Service Bulletin

Bulletin No: 11 001 08(013)

Subject: Rattling noise from engine during start up
K1200R, K1200S, K1200GT

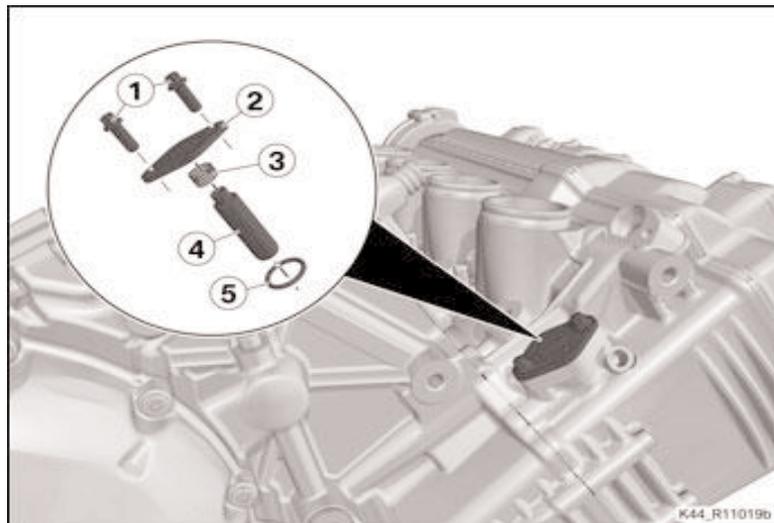
Service Measures: The oil reservoir can be retrofitted in response to customer complaint. Remove the timing-chain tensioner.

1. Remove screws (1), while holding cover (2) against the force of the spring (keep these screws for subsequent re-installation).
2. Remove cover (2) with guide for the clutch pressure line, if fitted.
3. Remove timing-chain tensioner (4) with spring (3) and spacers, if fitted.
4. Remove seal (5).

Note: There is a difference between the timing-chain tensioner for the K40, K43, K43HV and the timing-chain tensioner for the K44 (lettering) and it is very important to install the correct component.

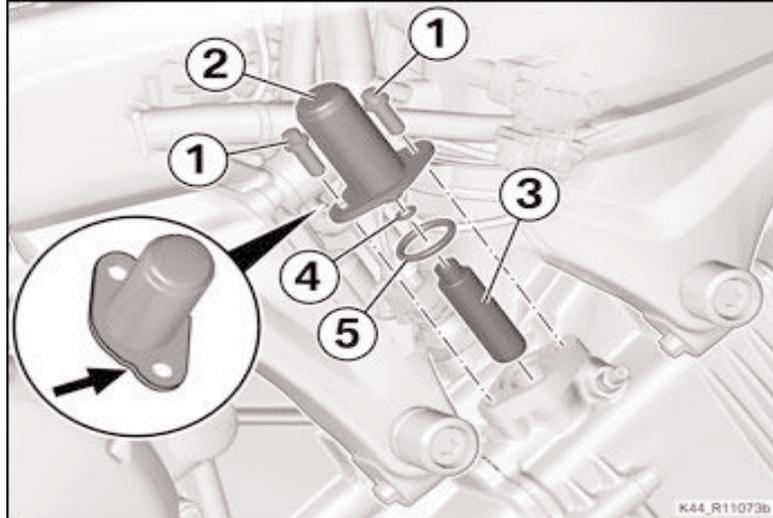
Install the new timing-chain tensioner with oil reservoir.

1. Install seals (4) and (5).
2. Install timing-chain tensioner (3).
3. Position oil reservoir (2) with the recess (arrow) toward the inside.
4. Hold oil reservoir (2) down against the force of the pressure and secure it with screws (1).

Initial torque, 9 Nm

Back off, 90°

Final torque, 9 Nm

Note: After installation, start the engine briefly three times in succession (to fill the oil reservoir).

Rework, thermal insulator of K44 up to week 22/07

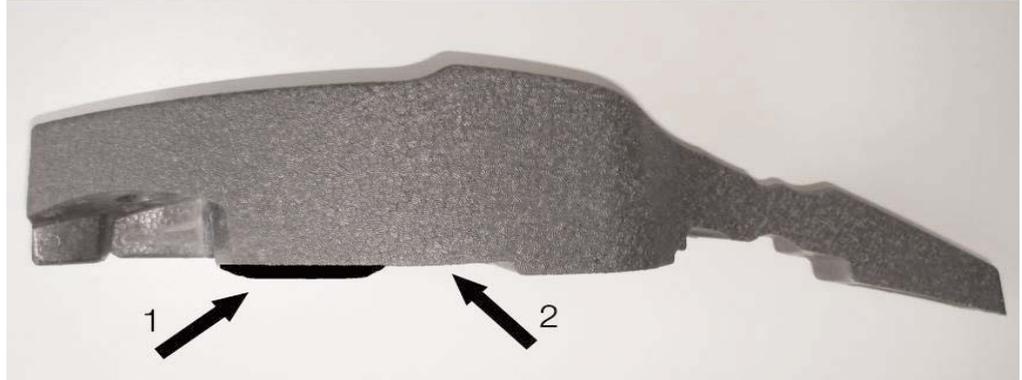
Use a sharp knife to match surface 1 (black) to surface 2.
